**PLANNING COMMISSION STAFF REPORT      NEW BUSINESS ITEM No. 1A & 1B**  
**MEETING DATE: MARCH 24, 2020**  
**PREPARED BY: KELLY DRAKE WOODWARD, AICP, CHIEF PLANNER**

**PROJECT NUMBER / TITLE: Z-20-04 Rezoning and PP-20-03 Breckenwood Creek**

# BRECKENWOOD CREEK

### PRELIMINARY PLAT

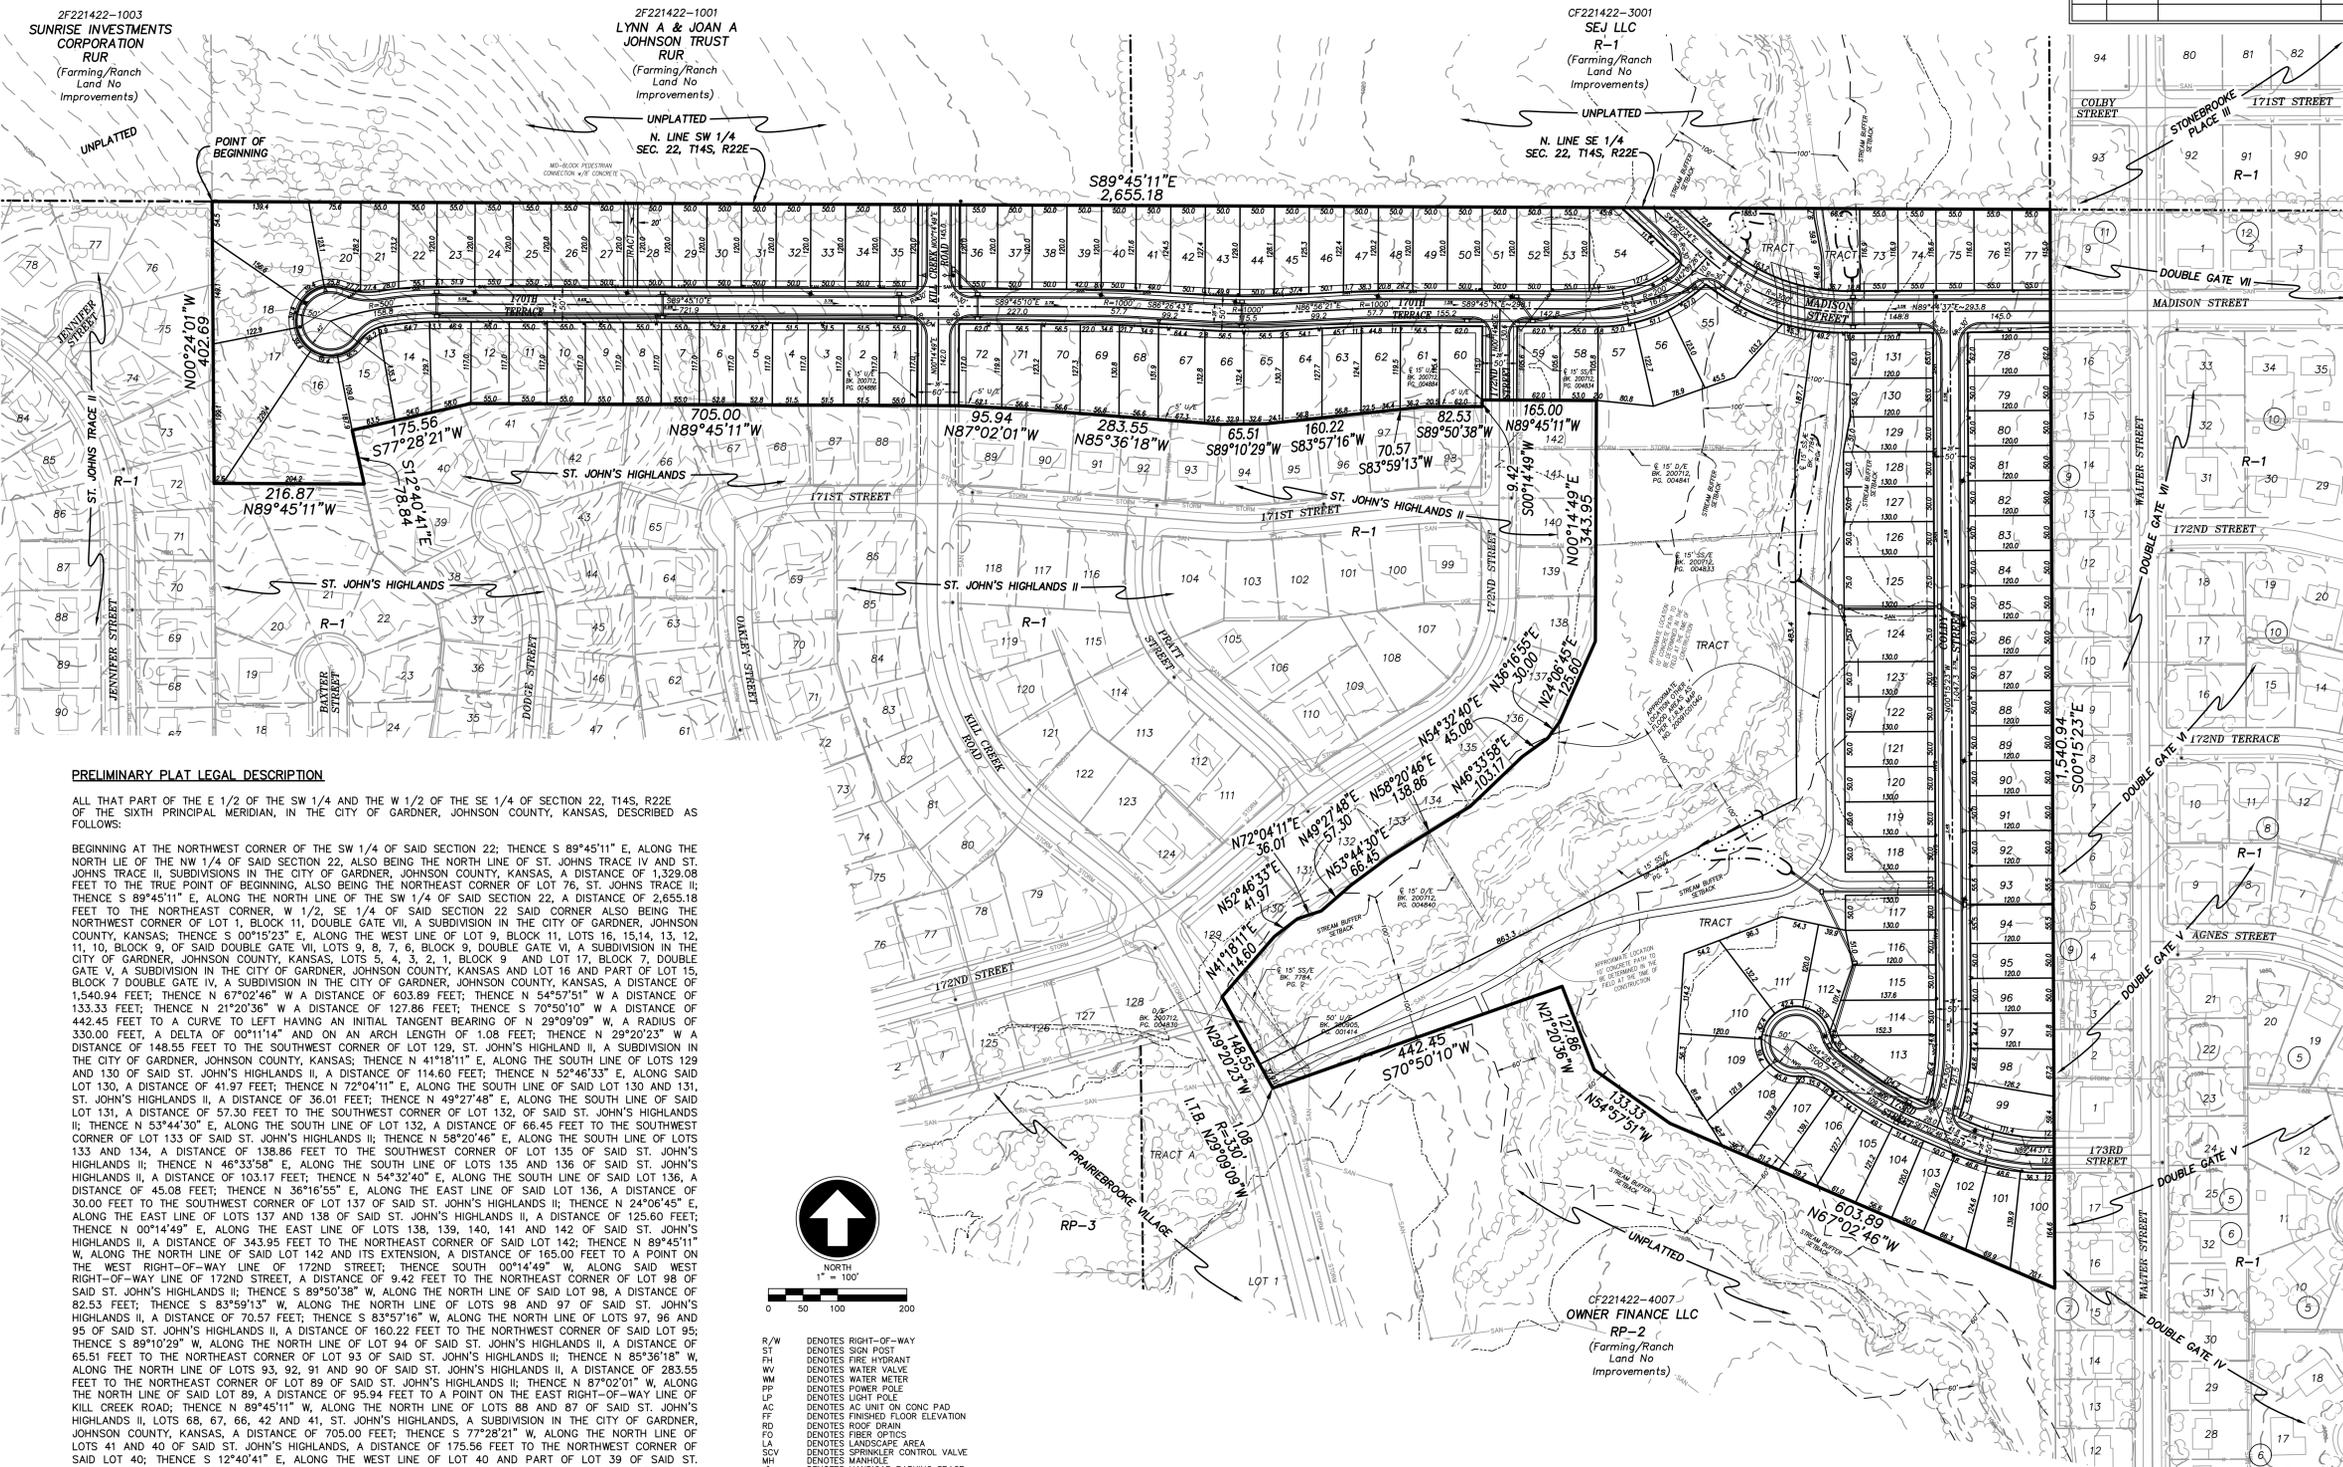
The Subdivision Standards of the LDC provide limits to block and cul-de-sac length. The proposed preliminary plat indicates cul-de-sac lengths consistent with plans approved under the former code, but which are longer than current standards allow. The LDC provides for **exceptions** to block and connectivity standards, stating that blocks abutting or containing important natural features, topographical constraints, or otherwise creating parts of the Civic Space system may be larger provided the proposed street layout preserves these features and integrates them into the overall structure of the community. This allows for an exception for the longer eastern cul-de-sac that preserves the floodplain area and provides a mid-block connection to the trail through the natural area.

The western cul-de-sac does not precisely meet this description for exceptions, but the area is constrained by existing residential development to the south which would not accommodate an additional local road to break up this block. The applicant states that there are four reasons they did not provide a stub street to the north of this cul-de-sac as follows:

Lot 58 does not meet the minimum lot area requirement of 6,000 SF. The applicant states that it is not being revised on the preliminary plat resubmittal because the stream corridor and the final design of the creek crossing improvements for Madison Street will most likely impact the lots to the east (55-57). The exact impact won't be determined until the time of final platting, and Lot 58 will be revised at that time. This is a recommended condition of approval.

1. Rezoning Z-20-04 is approved by the Governing Body;
2. Lot 58 will be revised on the final plat to meet the minimum lot area requirement;
3. Approval of the required Level 2 Transportation Impact Study by the City of Gardner Public Works Department.

## PHASING & VEHICULAR TRACKING PLAN

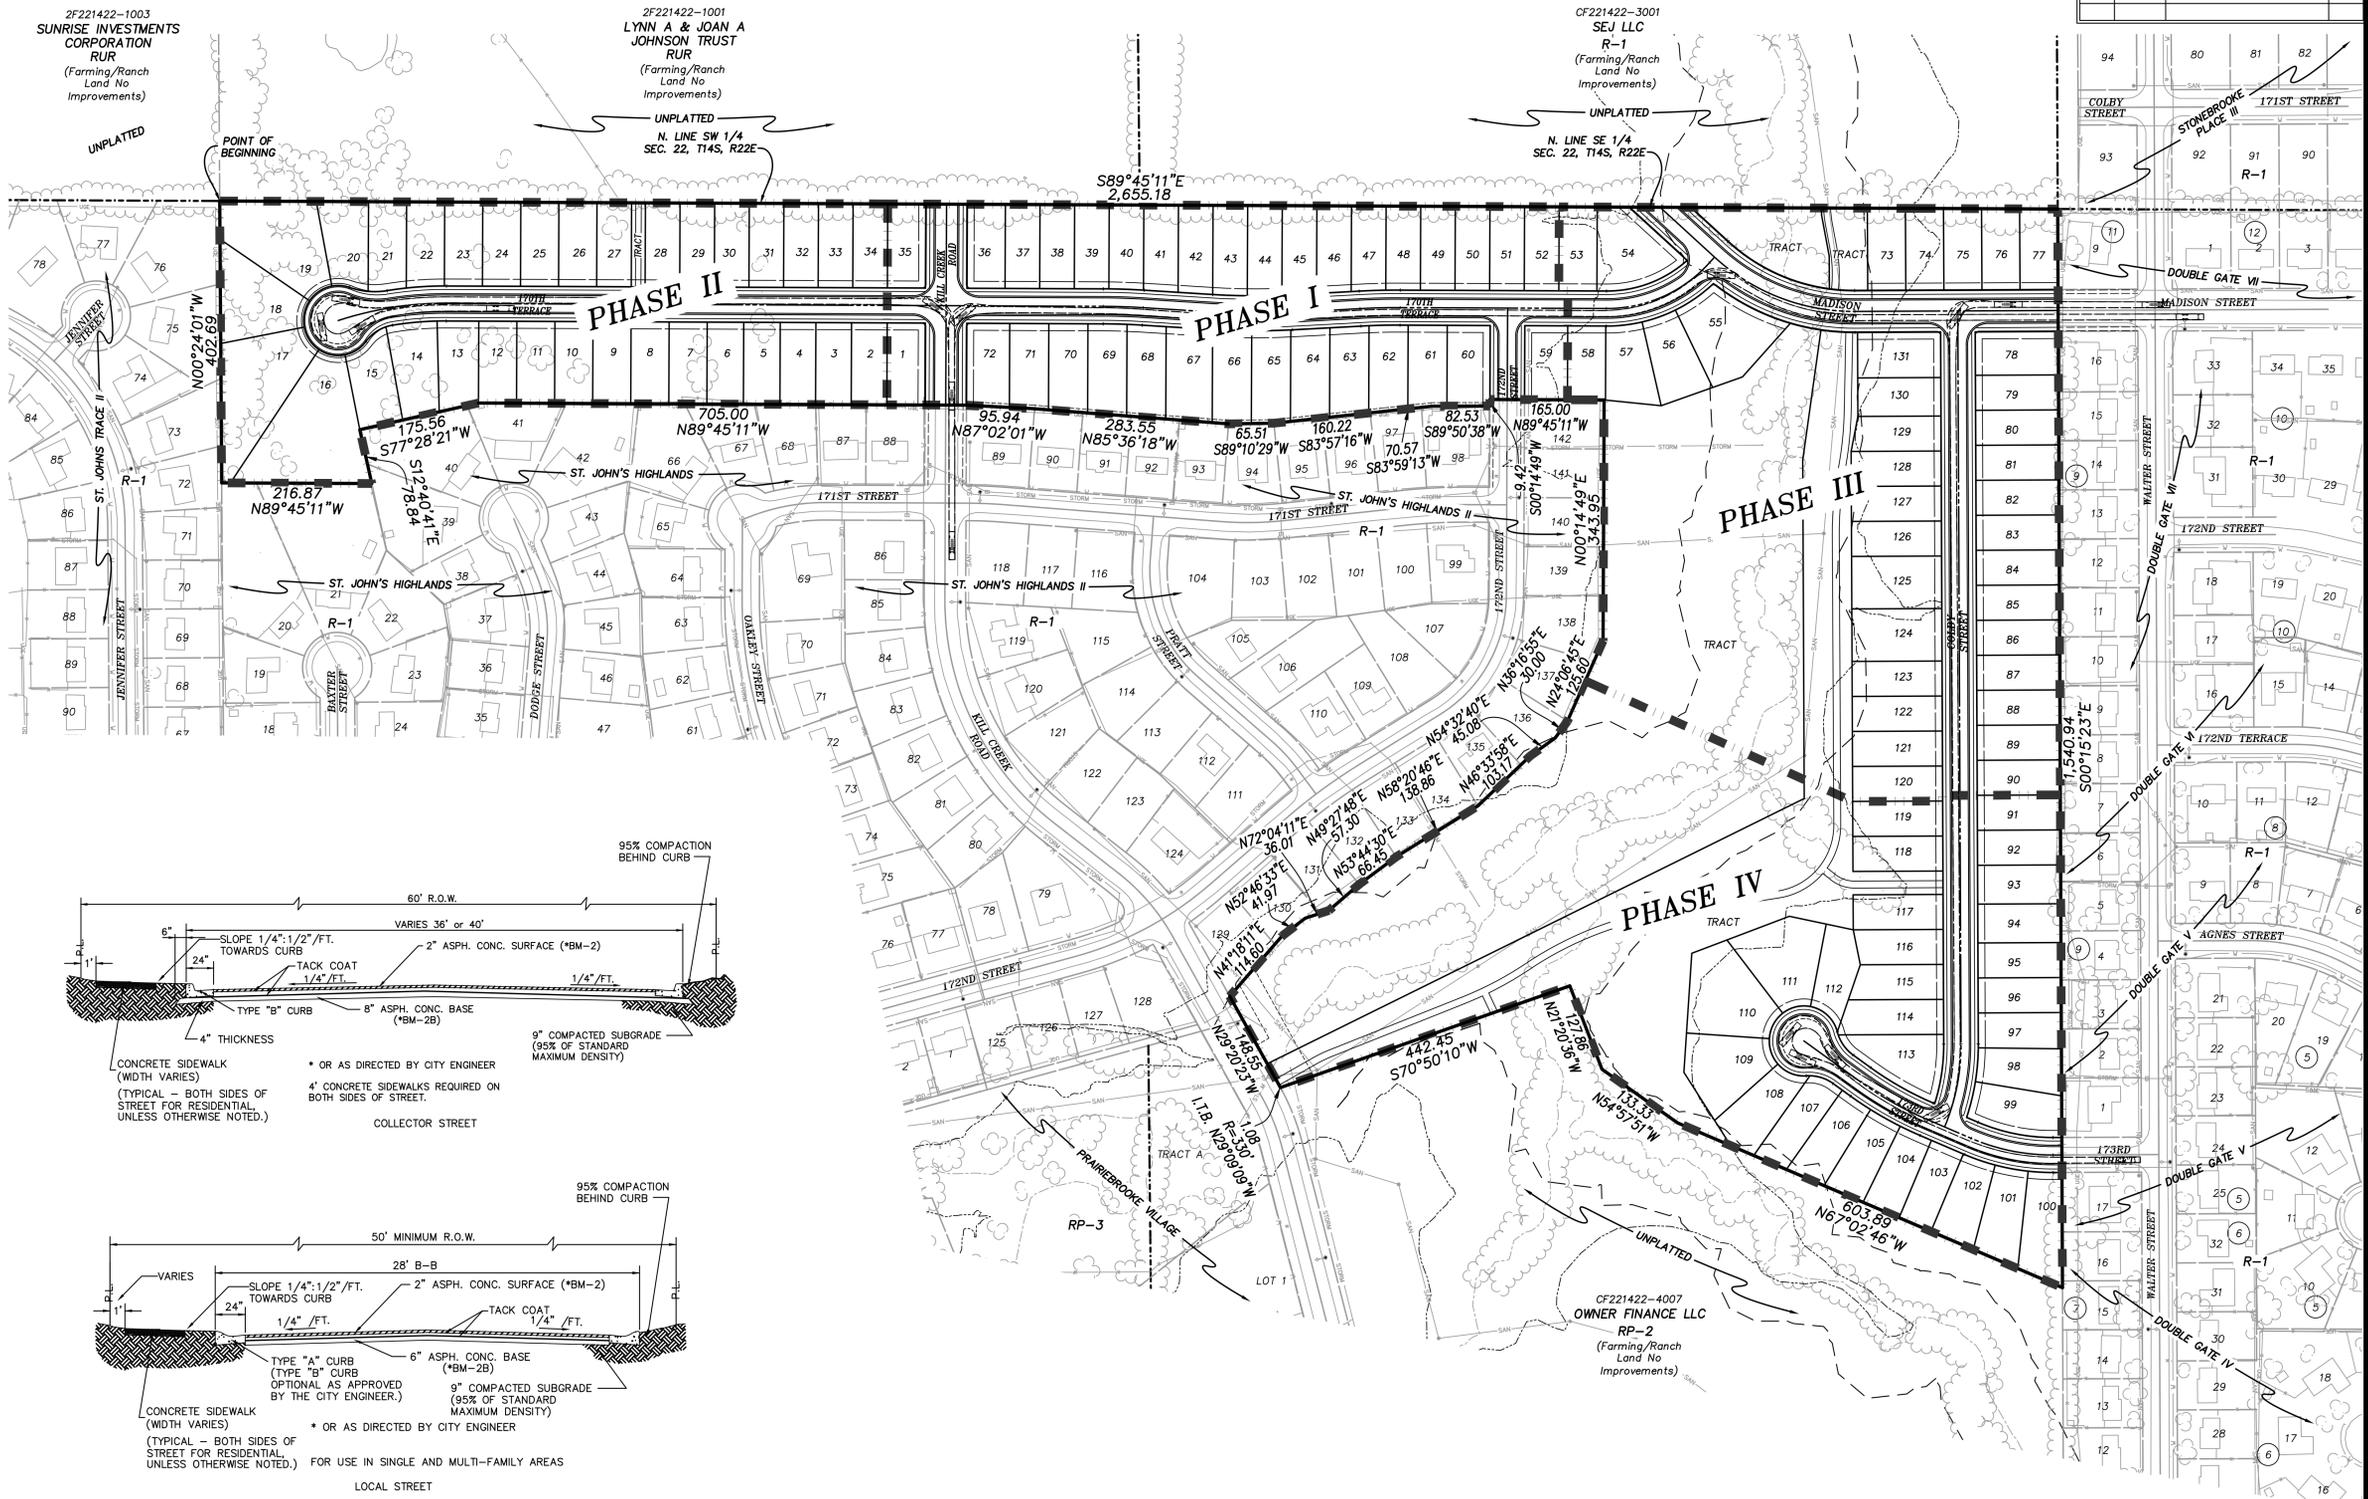
**Staff Comment:** *Per previous discussion, Staff finds this application to be consistent with many goals and objectives of the Comprehensive Plan, in particular the goals of housing diversity, infill development, infrastructure and recreational infrastructure connections, environmental protection and the reflection of intended residential character. The previously discussed exceptions to block and connectivity standards pertaining to the longer cul-de-sac lengths are mitigated by preserving natural features and integrating connected trails. The design provides for all feasible road and pedestrian connections, including two collector streets. It meets the intent for street networks to provide for efficient and safe movement of all potential users of the streets, to use streetscape design to call attention to differing contexts and better support development patterns and uses abutting the streets, and to increase connectivity and improve options for access in the community. The Fire District indicates support of the longer cul-de-sac length since the width is increased to better accommodate fire truck access.*
